Sundry Print Report

Well Name: BOIS D` ARC DIVIDE 22

Type of Submission: Notice of Intent

Type of Action: Plug and Abandonment

Proposed Wellbore Diagram

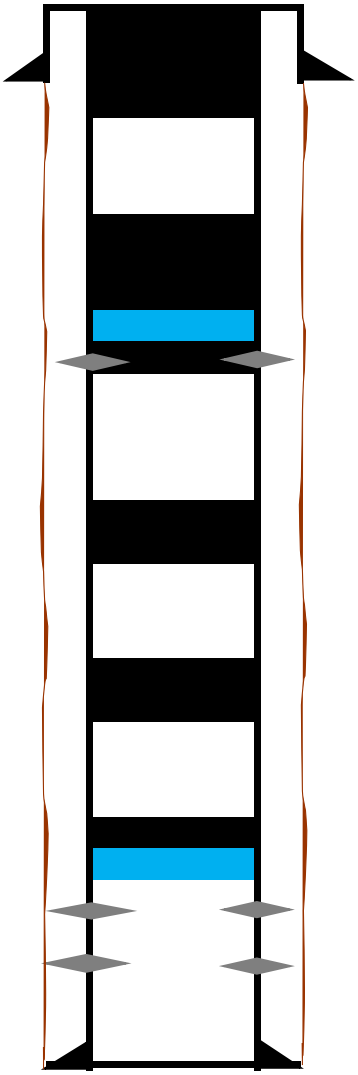
2. The following modifications to your plugging program are to be made:
   a. Bring the top of Plug #5 (Ojo Alamo, Kirtland and Fruitland) up to 880' to cover BLM pick for the Ojo Alamo top.

- Bring the top of Plug #5 (Ojo Alamo, Kirtland and Fruitland) up to 880' to cover BLM pick for the Ojo Alamo top.
- Fruitland Coal perfs 1447' – 1452'.
- Mesaverde (Menefee) perfs 3662' – 3276'. CIBP @ 3625' since 1/25/2005.
